Certificate of Appropriateness  
938 Spaight Street  
December 13, 2021

# Proposed Work

**1** PROPOSED EAST ELEVATION  
 A3 SCALE: 3/32" = 1' - 0"  
 12.9.21

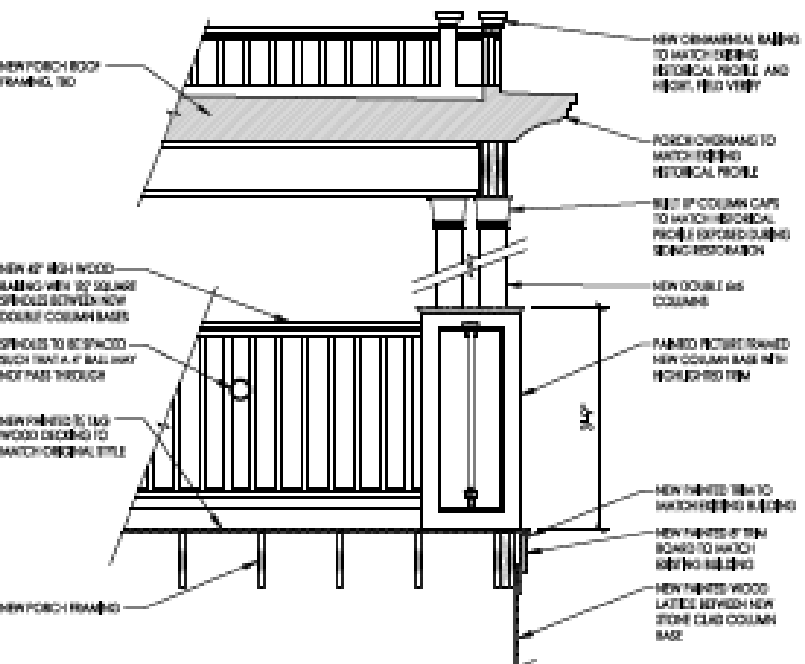
Staff believes that the standards for granting a Certificate of Appropriateness could be met and recommends that the Landmarks Commission approve the project with the following condition:

- Final railing specifications be approved by staff
